Re: Petition No. 1291  
Towantic Line Upgrade Project  
Change Location of Access Road at Structure #829

Change Location of Access Road at Structure #829

## TOWANTIC 1710/1730 LINE UPGRADES PROJECT

CITY OF MILFORD (NEW HAVEN COUNTY) AND TOWNS  
OF STRATFORD AND TRUMBULL (FAIRFIELD COUNTY), CONNECTICUT  
PAGE 14 OF 16

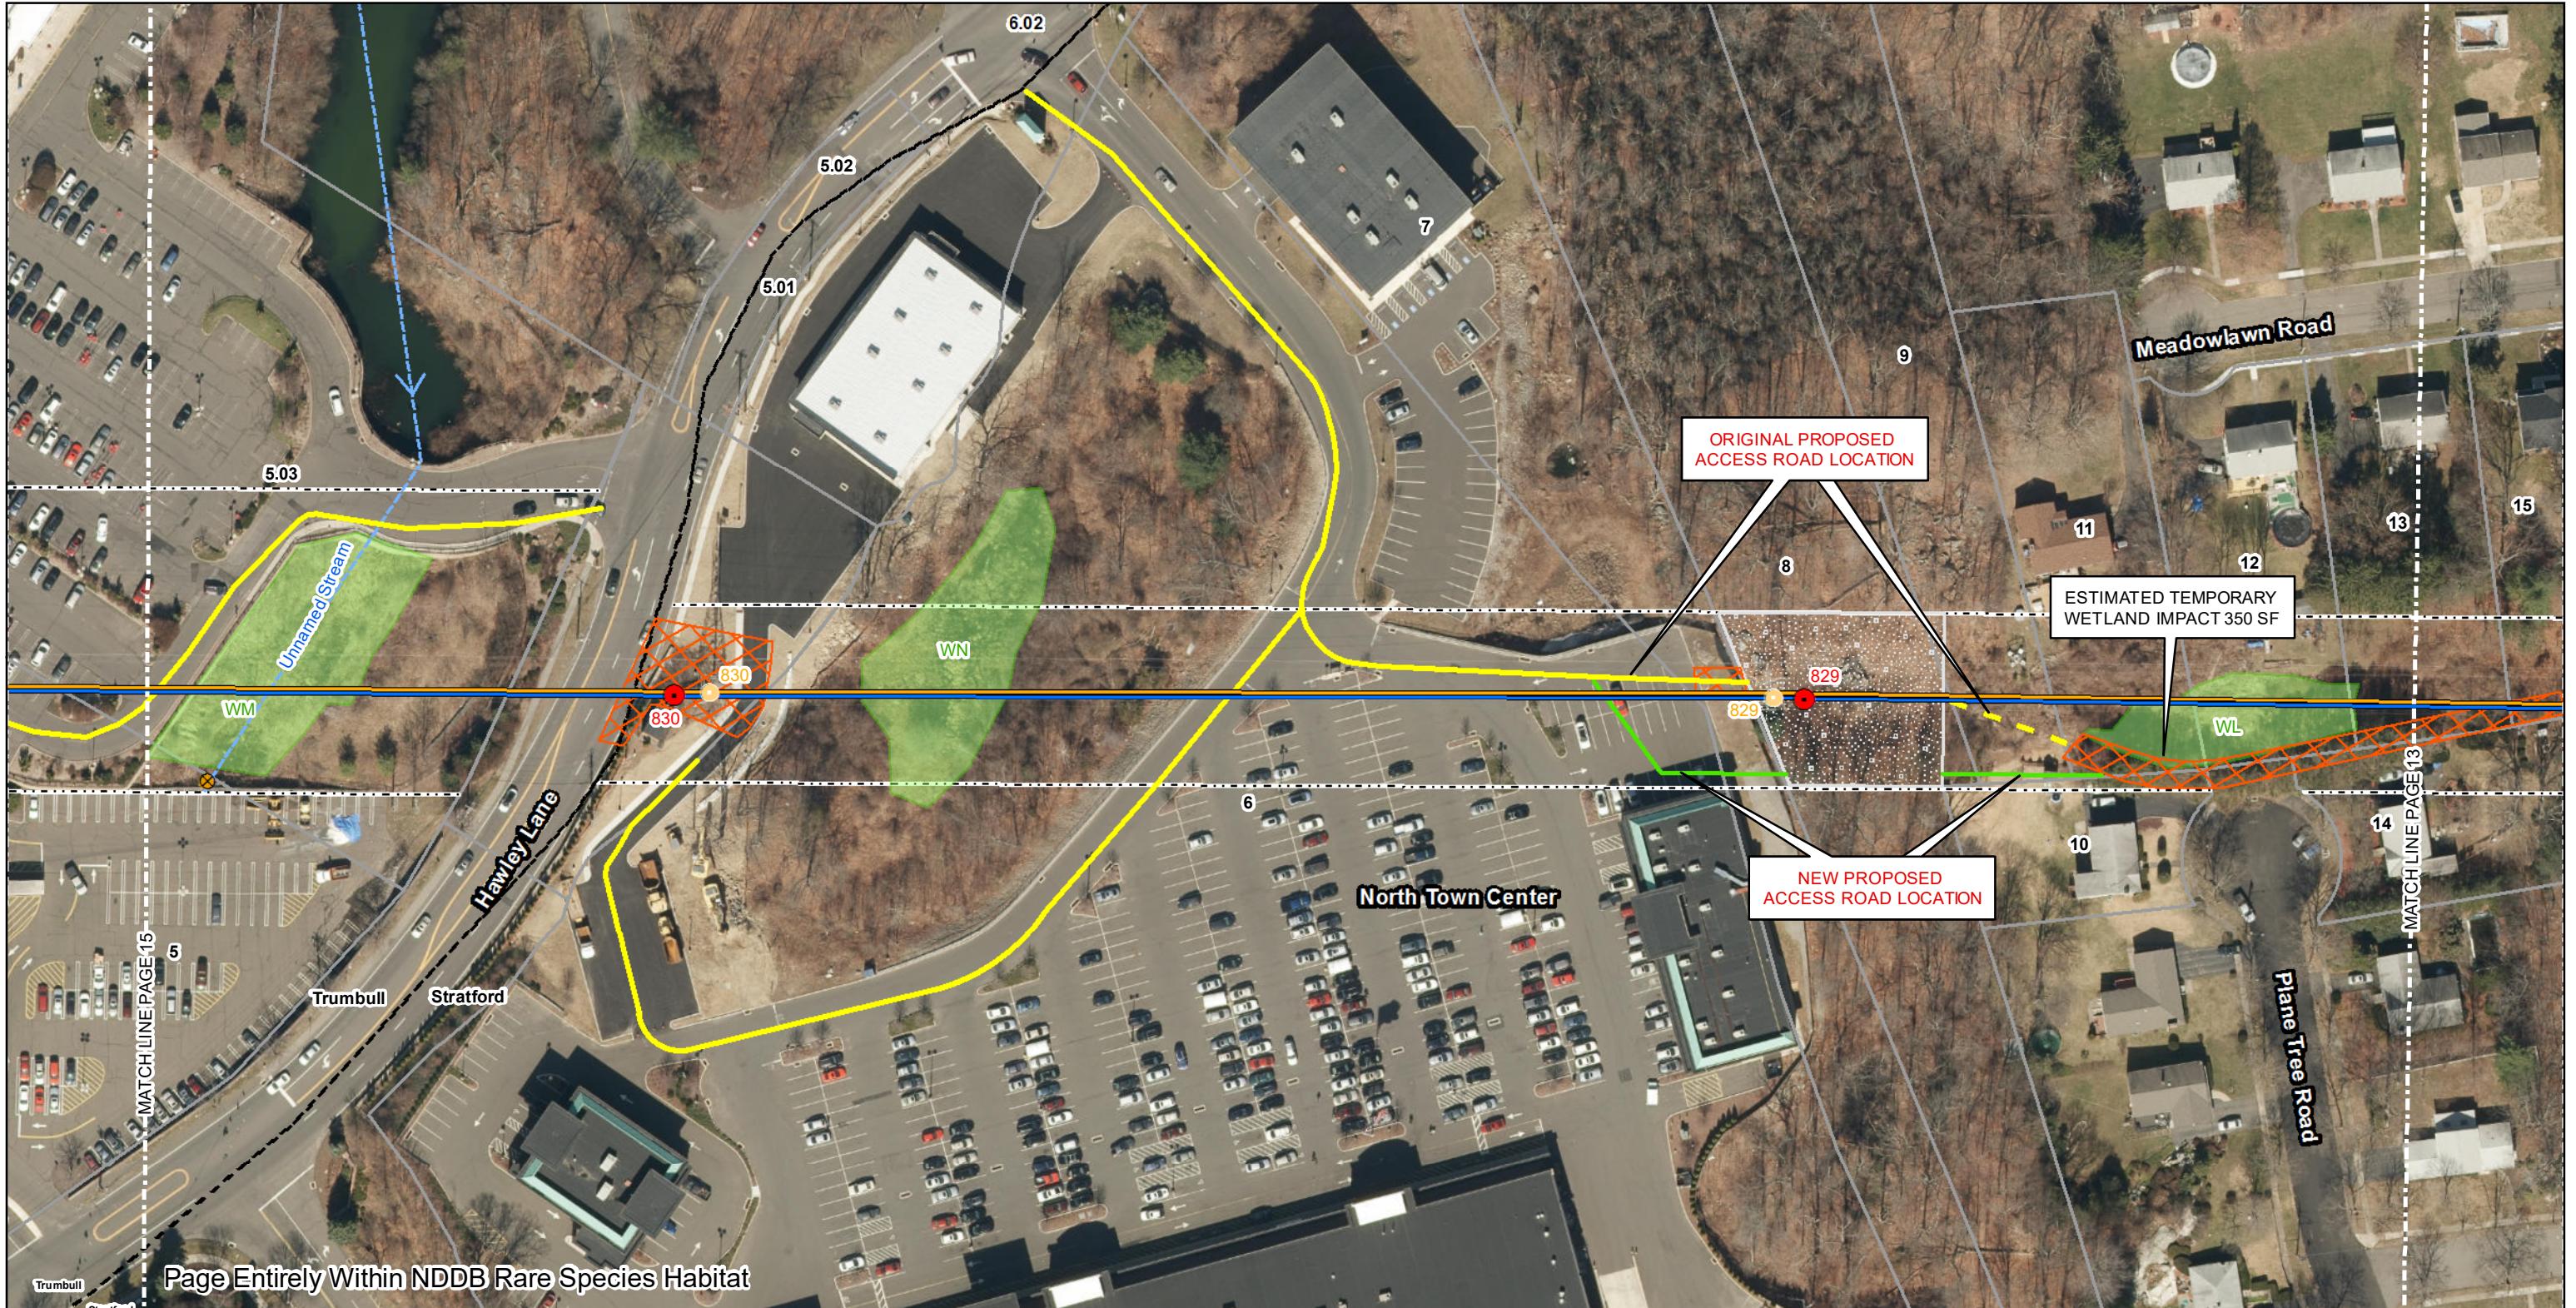
The location of this requested change is at Structure #829 which is situated northeast of the North Town Center in the Town of Stratford and is shown on the attached revised copy of Page 14 of 16 of the mapsheets submitted with the subject Petition (see Attachment A).

Eversource is requesting to shift approximately 100 feet of the proposed access road, located on the east side of the structure’s construction work pad, 50 feet to the south in order to avoid a 12 foot ledge that extends north from the center of the right-of-way (“ROW”). The new proposed access road will utilize an existing grade that is adequate for construction vehicles and will only require minor road improvements (i.e. gravel).

At this time Eversource is also requesting to substitute the use of approximately 150 feet of an existing access road on the west side of the same construction pad with a proposed new access road to be located approximately 50 feet to the south in to provide more space for construction vehicles to access the work pad for this structure.
